SUNDRY NOTICES AND REPORTS ON WELLS Do not use this form for proposals to drill or to re-enter an

Welch Federal #1 - P&A Procedure

Welch Federal #1

Wellbore Configuration - Proposed P&A

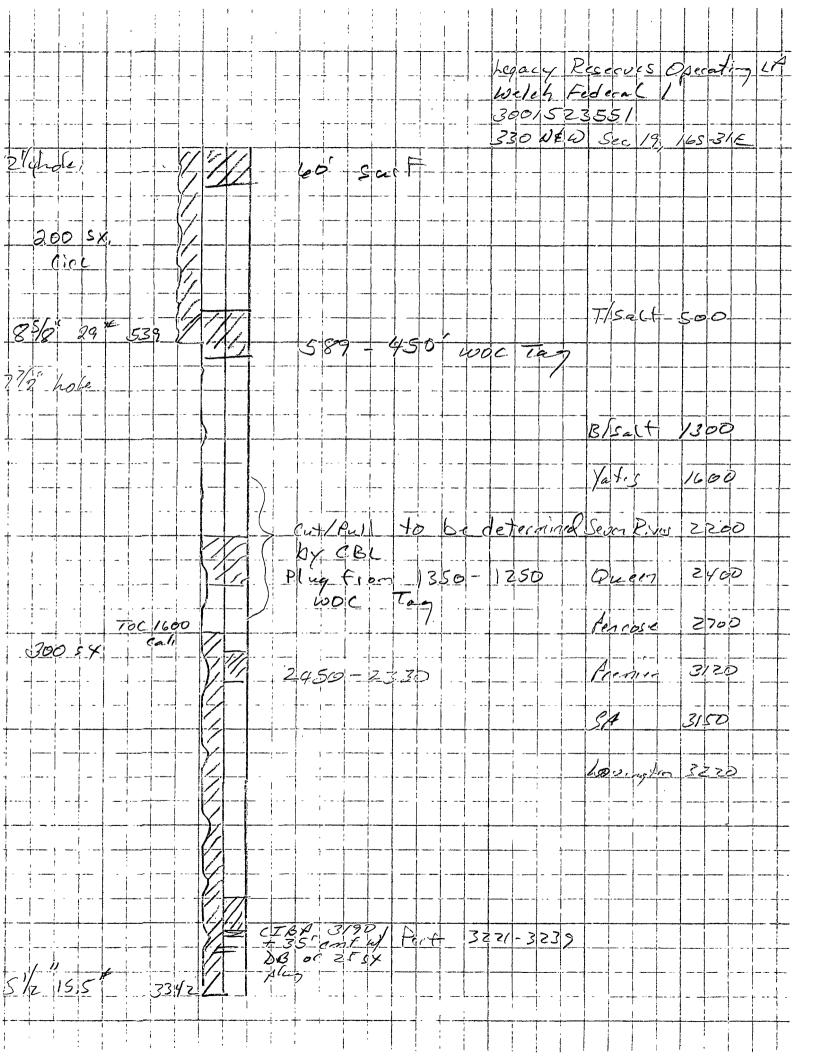
flugs to be set at specified depths. CBL to determine in perf & SQZ, or spot.

add plug Blsa 1250 1350 Com
